Subject: Idaho-Maryland Mine Project, Nevada County, CA

Acoustical Comments on Draft Environmental Impact Report

Salter Project 22-0039

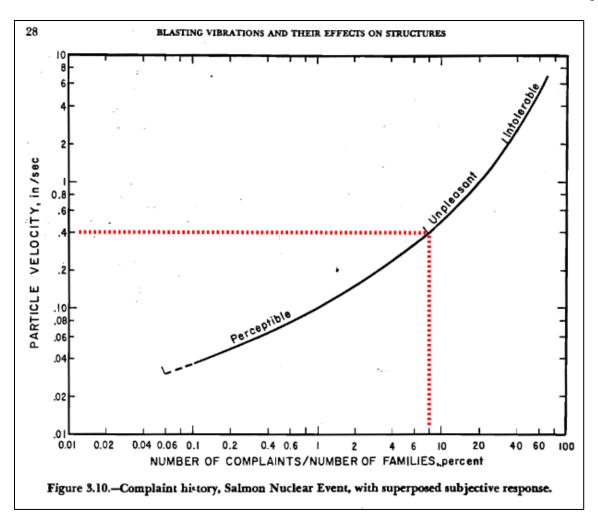
The 0.4 in/sec PPV vibration limit from the DEIR appears to be based primarily on a vibration study performed following an underground nuclear blast in Mississippi in 1964. The first concern is that human responses to this one blast may not be equal to the community response to ongoing perceptible and potentially unpleasant vibration over the 80-year lifespan of this project. Nevertheless, the DEIR references this study as it is described in Bulletin 656 titled "Blasting Vibrations and Their Effects on Structures" published by the U.S. Bureau of Mines (USBM) in 1971. The claim extracted from the USBM document is that "less than 8% of people would complain about blasting activities if the peak particle velocity (PPV) was below 0.4 in/sec." (DIER, Appendix M, page 7, paragraph 3). However, the original chart this is drawn from provides additional context. Figure 3.10 from Bulletin 656 is provided below with dashed lines highlighting the DEIR proposed limit:

The proposed limit of 0.4 in/sec. PPV is characterized as clearly perceptible and borderline unpleasant. This description is supported by the Caltrans Transportation and Construction Vibration Guidance Manual (April 2020). Table 21 below, an excerpt from the Caltrans Manual, indicates that blasting vibration of 0.4 in/sec. would be considered "strongly perceptible."

The 0.4 in/sec. vibration limit might be appropriate in certain scenarios, such as a short-term event. However, this project involves ongoing mining operations for 80 years. In our opinion, potentially subjecting residents to "strongly perceptible" and borderline "unpleasant" vibration on a regular basis for the rest of their lives should be considered a significant impact. This is particularly true for evening and nighttime operations, which is the subject of our next comment.
